**To:** Russell Butchers, Auckland Council  
cc/- Drury Metropolitan Centre Consolidated Stages 1 and 2 Expert Panel

**From:** Mary Wong / Pamela Santos – Barker & Associates Limited

**Date:** 24 July 2025

**Re:** Response s67 further information memorandum recommended by Auckland Council

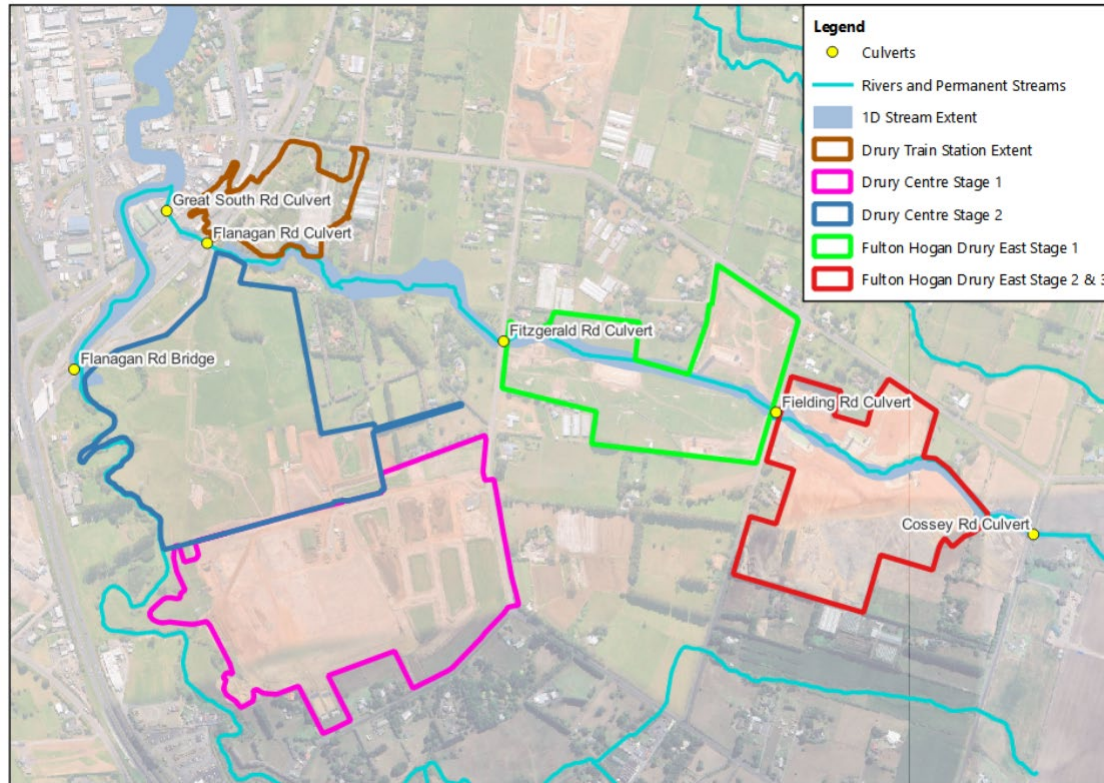
1	<p>A copy of the Applicant's flood model for the Fitzgerald Stream including all of the modelled pre-development model and post-development scenarios. This should include:</p> <ul style="list-style-type: none"><li>a. Additional modelling and associated assessment of effects for the Fitzgerald Stream relative to existing land use and no climate change.</li><li>b. Additional modelling and associated assessment of effects for the Fitzgerald Stream considering 3.8-degree climate change.</li><li>c. Provide the modelling and associated assessment of effects for the flow attenuation scenario.</li></ul>	<p>The models and associated effects are attached for the following scenarios as requested. It is noted the models have been updated since the submission on 21/03/2025 with comments that have been received from Healthy Waters as part of the model review undertaken for the Fulton Hogan Drury East Stages 2 and 3 SIMP. Given the model review, it was deemed appropriate that the same review comments were implemented in the Drury Centre models being used for this application to ensure consistency between models.</p> <p>Therefore, the models and results for the following scenarios can be found in <b>Attachment 1</b> (flood depth plots), <b>Attachment 2</b> (water level difference plots) with a summary provided below. The areas being discussed is shown in the figure below.</p>

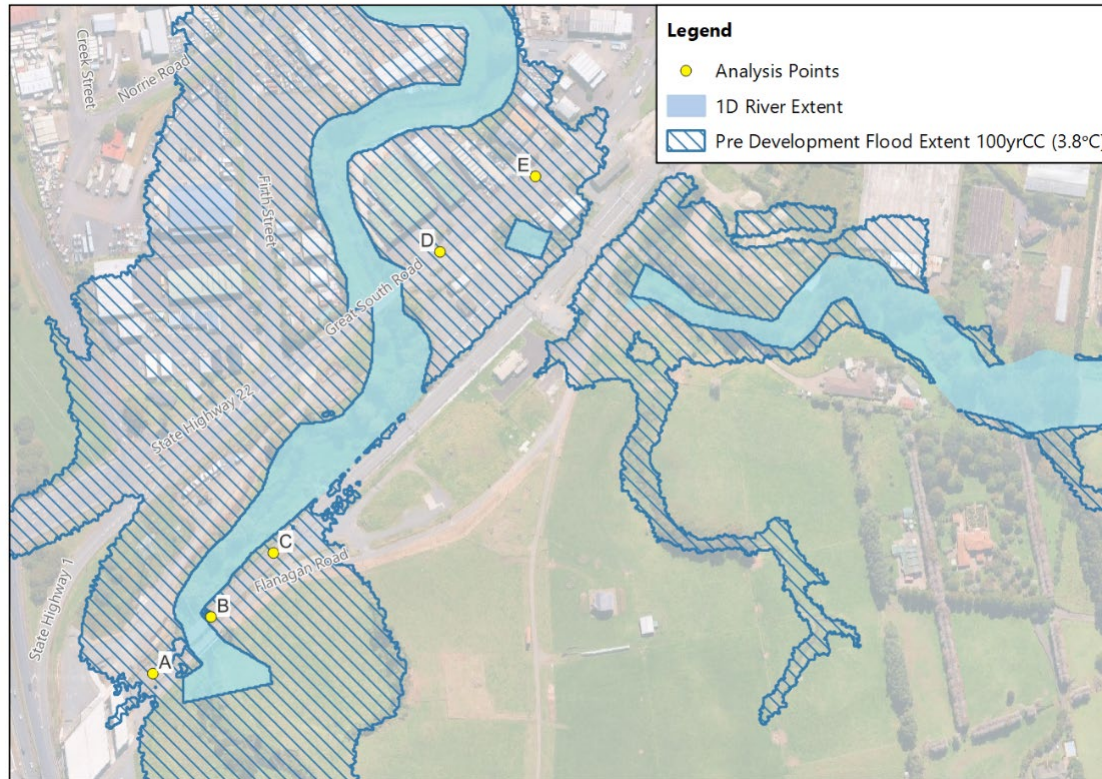
30	<p>A Flood Hazard Risk Assessment Report was prepared against AUP Chapter E36.9 Section a, which included flood frequency, duration and scale. The assessment prepared by the Applicant speaks to the scale of flooding (i.e., peak flows and peak depths/extents) but does not assess scale or duration. Can the Applicant provide further information to demonstrate that flooding does not occur more frequently or for a longer duration as this could have significant</p>	<p>Information on duration of flooding on existing roads (Flanagan Rd and Great South Rd) has been provided for the points located as shown on figure below.</p>

The analysis undertaken (Table 1) summarises that the duration of flooding has negligible change, the differences observed are limited to the 100-year scenarios with increases in inundation time generally less 8mins for full post development which is inclusive of Drury Centre and Fulton Hogan Drury East Stage 2 and 3. Similar to the response provided in Query 1 for Area A, the increases (less than 8 mins) are not considered to be attributed to Drury Centre Stage 2 development as the comparison undertaken allows for the full upstream Fulton Hogan Drury East Stage 2 and 3 developments and this is summarised in Table 2.

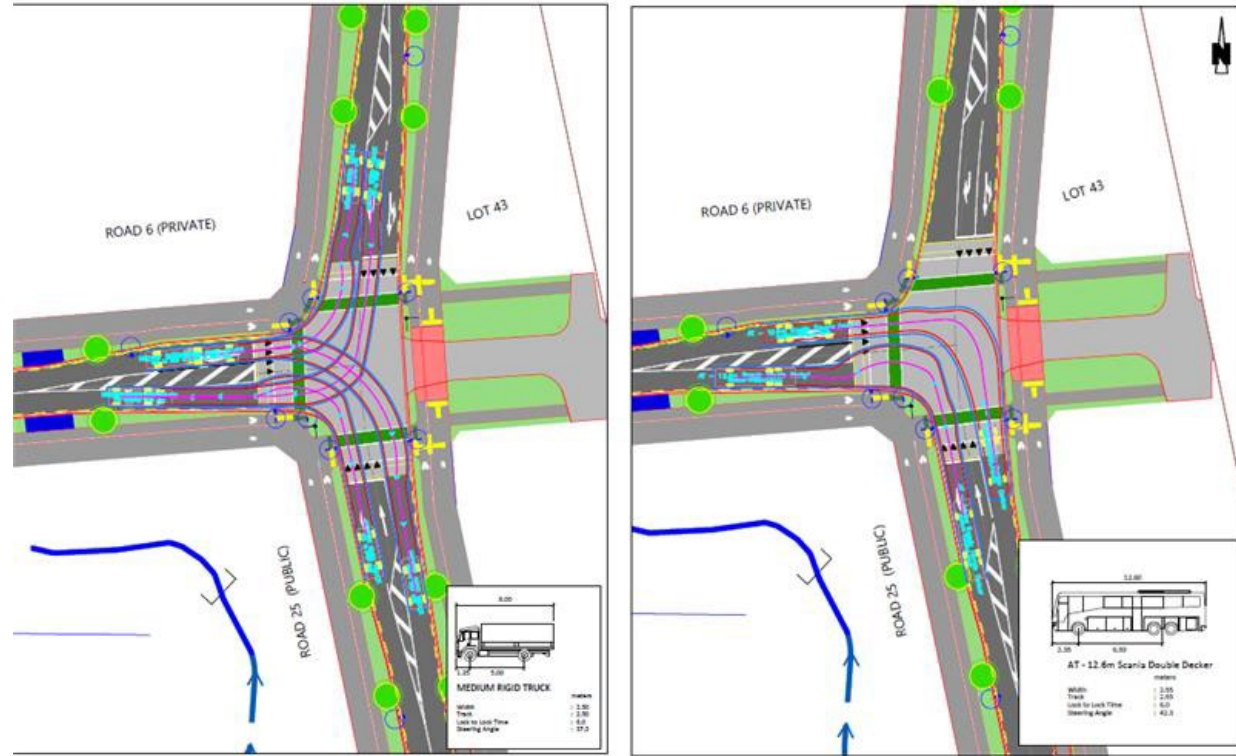
It appears that none of the 292 vacant residential lots under Stage 1 will seek access off Brookfield Road or Fitzgerald Road. The Applicant should provide further information to demonstrate what planning mechanism they will use to ensure access onto these roads directly does not occur.

The configuration of the fee simple subdivision in the Stage 1 Residential area has been designed such that none of the proposed lots would gain vehicle access directly from Fitzgerald Road or Brookfield Road. This specifically applies to superlot 11, 15, 18, 19 and 22 which have frontage to these roads. The subdivision layout deliberately includes JOALs to provide vehicle access from the rear and not directly from Fitzgerald or Brookfield Road for traffic safety purposes.

To ensure this, it is considered appropriate to include a consent notice on the relevant lots (Lots 1114-1118, 1506-1513, 1808-1814, 1907-1919, 2205-2217) which prevents vehicle access directly from Fitzgerald or Brookfield Road. This is now included in the revised proposed consent conditions in **Attachment 5**.

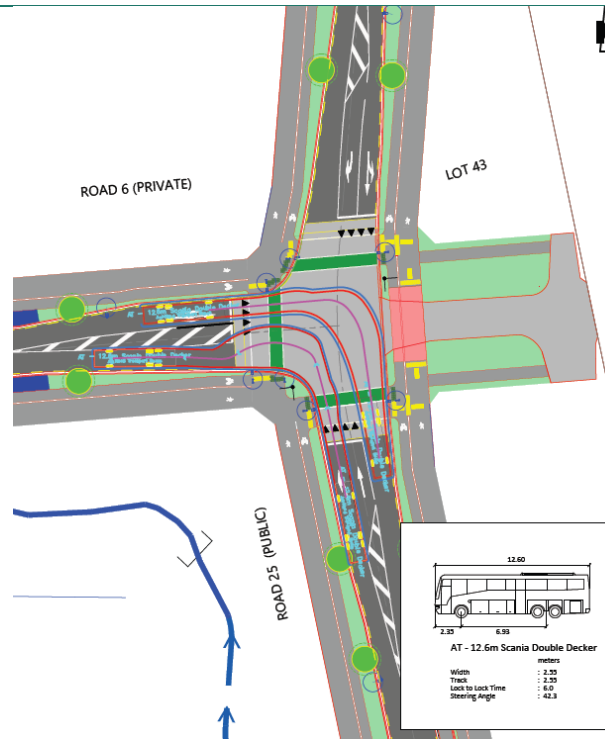
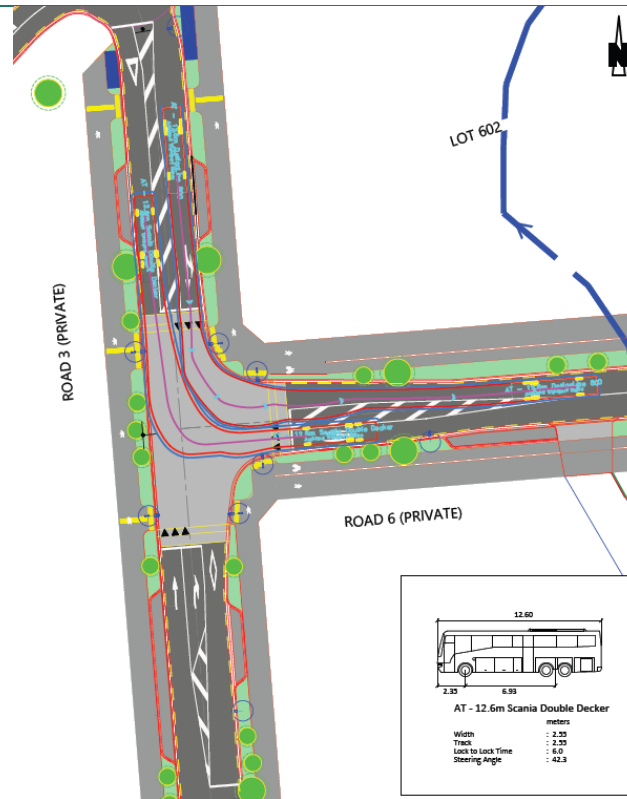
We recommend that the applicant provide further assessment of the potential safety and efficiency effects for users of the JOAL and road users for the adjacent road network	
34	<p>Stage 2 General</p> <p>Some of the Lots appear to have no pedestrian facilities connecting to and within the carparking area. It is likely that some pedestrians will enter the sites via the vehicle crossings and people who park will be walking through the carpark area. We recommend that the applicant provide further detail on how the carparks will provide safe pedestrian access and circulation. This should include trolley bays and paths should accommodate trolley widths.</p>	Proposed condition 24(a) wording in <b>Attachment 5</b> has been updated to include final locations of pedestrian paths and trolley bays within carparking areas to be provided as part of the final architectural design plans.
35	Only limited vehicle tracking assessments are provided for proposed private roads and within sites, and the assessments that are provided lack sufficient detail to allow suitable review. We recommend that the applicant provide detailed vehicle tracking assessments for the expected	<p>All the relevant vehicle tracking checks at the intersections within the internal Drury Metropolitan Centre network have been carried out. In summary, there will be some refinement to kerb lines in most instances and vehicle tracking demonstrating proposed changes are included as <b>Attachment 7</b>.</p> <p>Road 13 has been designed to accommodate 17.9m or a 19.45m articulated trucks. From Road 13, these vehicles can connect to the wider road network via Road 25 and Road 1 to the south and Road 2 to the north or south. All other intersections within the site have been designed to accommodate an 8m design vehicle and an 11.5m check vehicle and a 13.5m bus where appropriate. Consequently, all roads (other than Road 13) will require a</p>

<p>types of vehicles that will use these roads and access sites.</p>	<p>departure from standard application. To ensure the operating speeds of all intersections are around 30km/h, as discussed prior to lodgement and similarly to the Road 1 designs, all intersections are to be raised.</p> <p><u>Interim bus routes – Road 6 intersections</u></p> <p>Road 6 will accommodate buses for the interim period until the bus route until the Road 25 connection is made to the north to connect with the bus station.</p> <p>Both intersections with Road 6 (Road 25 and Road 3) have been checked using vehicle tracking analysis. TDM requirements include a check vehicle of 17.9m, however, as this vehicle is not anticipated to use this part of the internal road network and to ensure that the road carriageway is as narrow as possible, these intersections have been designed using the 8.0m rigid truck design vehicle, shown below for reference.</p>

As Road 6 is not anticipated to be used by buses in the longer term (once Road 25 is connected directly to the bus station to the north), it was decided to implement an interim design on Road 6 at its intersections with Road 25 and Road 3, rather than significantly widen those intersections to accommodate buses.

The interim designs will consist of converting the additional approach turning lanes on Road 6 to extra wide receiving lanes that can accommodate the bus turning. Once the busses no longer use this Road 6 route, the turning lanes will be reinstated. The tracking is shown below for clarity.

Overall loading space location plan:

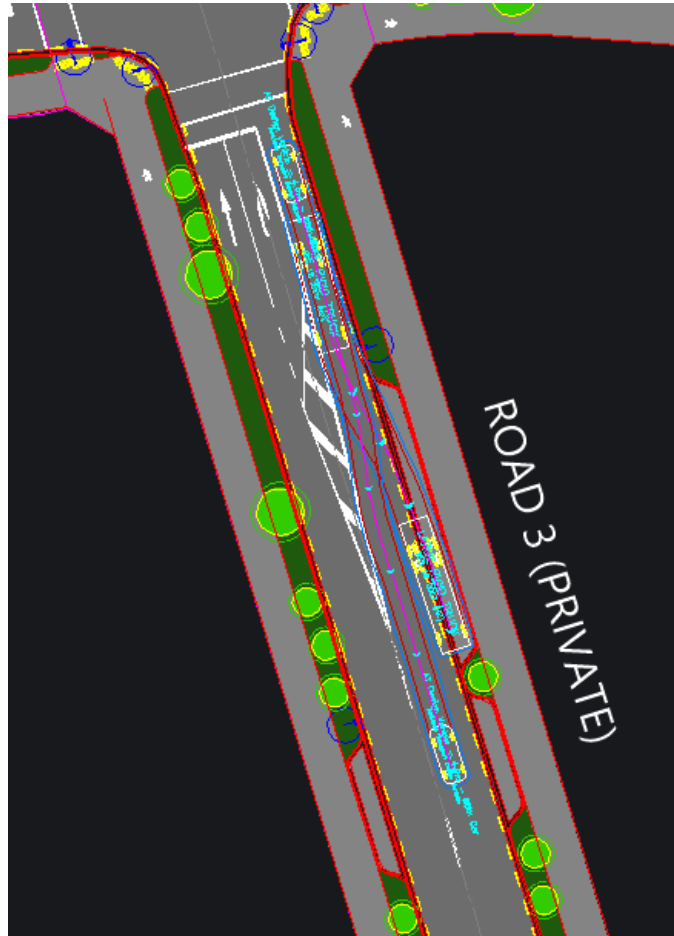
38	Lots with multiple tenancies have one or more loading areas near the major tenancies. It is unclear if the minor retail tenancies will have access to the loading areas. We recommend that the applicant provide further detail on how minor retail tenancies will conduct loading operations	<p>New on-street loading spaces have been introduced onto Roads 13 and 3 to accommodate loading for the smaller tenancies, and the updated plan sets reflect this. Care has been taken to ensure that vehicles parking in loading spaces would not obstruct sightlines to mid-block pedestrian crossings. The overall image showing their locations is below, alongside vehicle tracking for each. Please see also updated Architectural set (sheet 00-1101 for overall site loading bay location updates and pleas A-1301, D-1301, H1-1302 &amp; H2-1302) included as <b>Attachment 11</b> for loading bay location updates within each lot.</p>

It is considered that each location is safe and a logical position to undertake loading activities. In detailed design / EPA, further details on berm crossing locations etc will be provided.

Lot A:

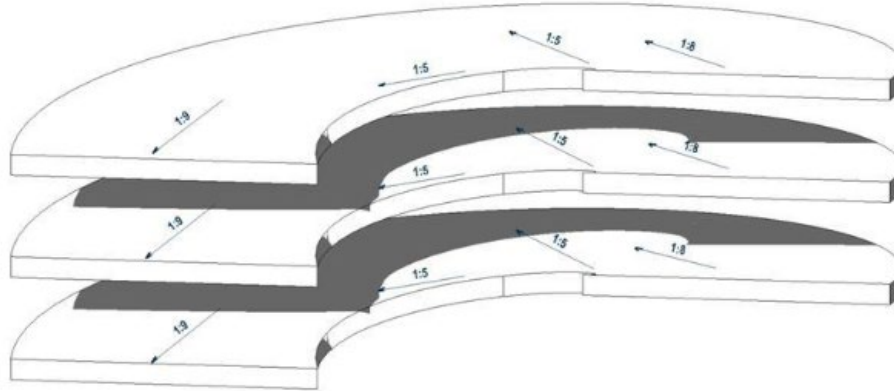
Some lots have multiple levels of car parking, accessed by a mix of straight and curved ramps. Vehicle tracking and ramp gradients (along the inside curve for curved ramps) do not appear to be included in the application documents. Further, it is unclear how driver interaction at the toe/head of

the ramp will be managed – i.e. whether give way markings are required and how the ramp will be physically separated from the adjacent parking aisle. We recommend that the applicant provide further assessment of these matters.

Lots A, B, D and E contain curved ramps and are assessed below with the gradients identified within the inside bend of the ramp. The proposed gradients are provided with sufficient transition sections to ensure that the underside of the vehicle does not strike the ground.

The steeper gradients on the inside edge of the ramp are due to the curved alignment, since the inside radius is shorter, the same change in elevation results in a steeper slope compared to the centreline or outside edge. This is a common outcome in curved ramp design. On the straight ramp sections, gradients comply with development control T159 of the Unitary Plan, as the longer travel distance allows for a more gradual elevation change and better control over the slope.

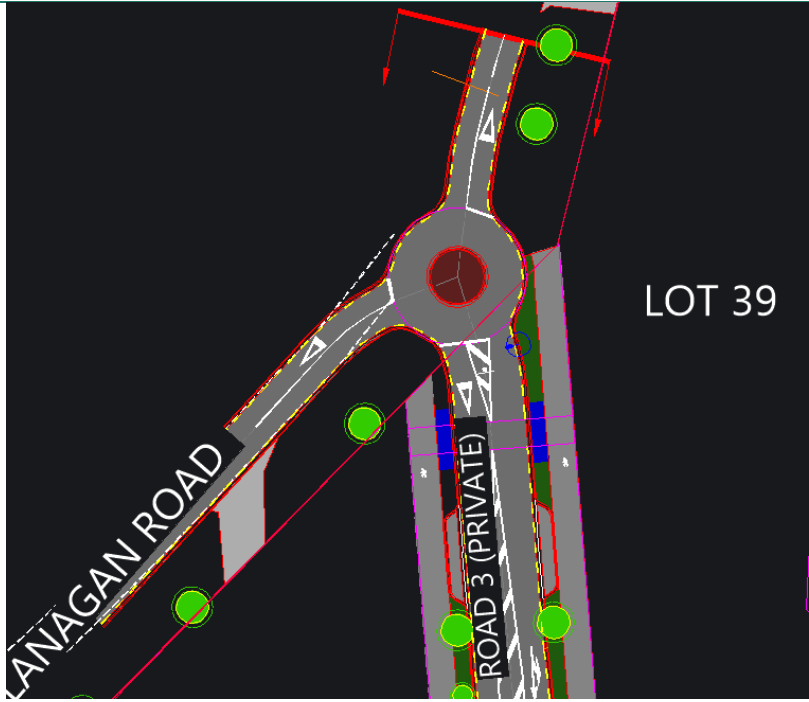
41	<p>Architectural Drawing A -1301 shows a footpath on Road 13 and Road 2,</p>	<p>Please refer to the revised footpath layout in both referenced architectural drawing set included as <b>Attachment 11</b>. No footpath is proposed on the Eastern side of Road 2, due to this being the continuation of the proposed</p>

<p>along the site frontage of Lot A. However, Woods Drawing 2001-DR shows the footpath on Road 13 terminating halfway along the Lot A frontage, and no footpath on Road 2. We recommend that the applicant consider how pedestrians will access Lot A, including people who may park in the Lot A carpark and seek to access the footpath on Road 13 and/or Road 2.</p>	<p>SH1 offramp and overbridge and it is not considered an appropriate space for pedestrians. In addition, the buildings fronting Road 2 are multi-level carparks, with the town-centre further East. Road 2 is not expected to have any pedestrian demand apart from access to the shared path that is proposed within the Hingaia Reserve. A crossing is proposed at the signalised intersection of Road 2 with Road 13.</p>
42	<p>Architectural Drawing F1-1301, H1-1310, and H2-1301 show a footpath on Flanagan Road, along the site frontage of Lots F1, H1 and H2. However, Woods Drawing 2004-DR shows that only street trees are proposed on Flanagan Road, with no other urbanisation (including the absence of a footpath). We recommend that the applicant consider how pedestrians will access Lot F1, and who will undertake urbanisation of Flanagan Road along the site frontages.</p>	<p>Refer response provided in item 22 above – Flanagan Road is not proposed to be upgraded to an urban standard. However, a mini-roundabout has been introduced at the intersection of Road 3 and Flanagan Road to ensure good connectivity at that location.</p>

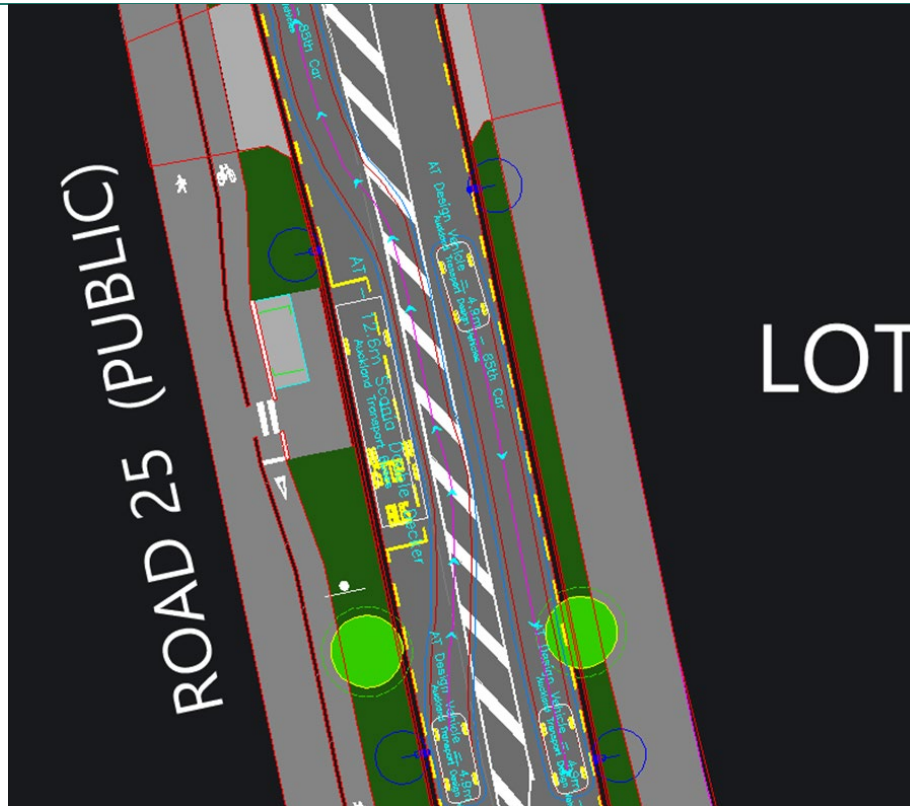
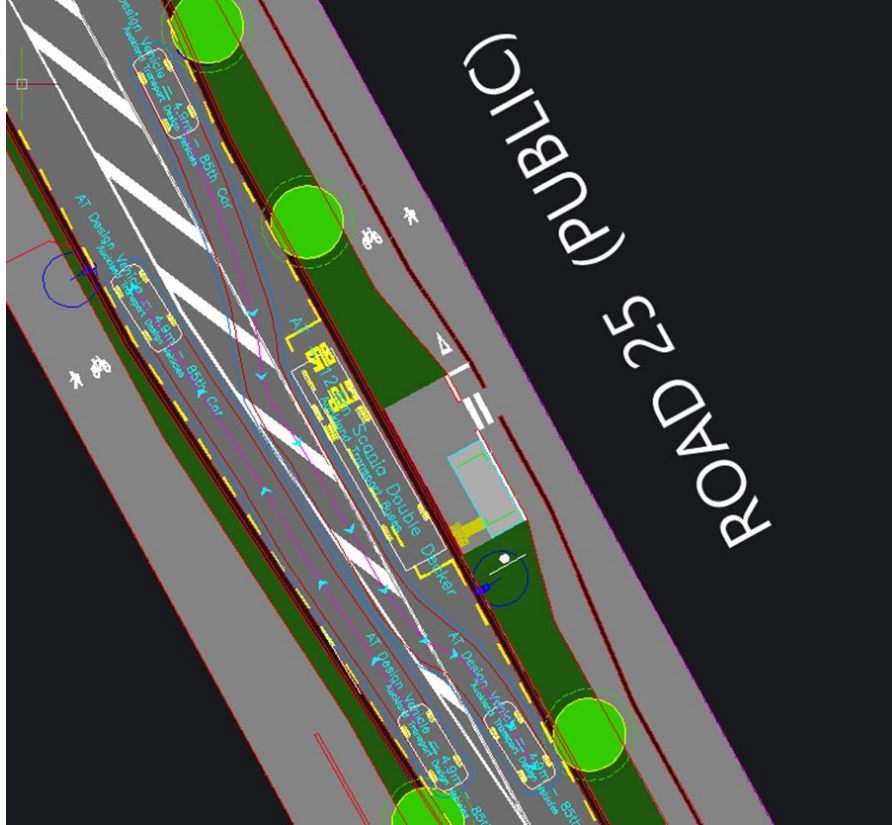
43	<p>Woods Drawing 2003-DR shows Road 11, west of Road 3, as “FUTURE ACCESSWAY”. However, the</p>	<p>Please refer to the updated engineering drawings set (<b>Attachment 8</b>), which now detail the former accessway as a privately owned road. Snip below.</p>

<p>Architectural Drawings show that this road is required to access Lot D and Lot F. We recommend that the applicant include the design of this road within the civil engineering drawing package.</p> 	
<p>44</p>	<p>Woods Drawing 2053-RD shows the intersection of Road 3 and Flanagan Road, although it is acknowledged this lies just outside of the boundary of the Drury Stage 2 extents. There is no detail of intersection treatment or consideration of any requirement for turning bays. We recommend more work be undertaken to determine the intersection control and layout.</p>	<p>Please refer to the updated engineering drawings set (<b>Attachment 8</b>) which now detail that a mini-roundabout will be provided at this intersection. A snip showing the design is provided below for ease of reference.</p>
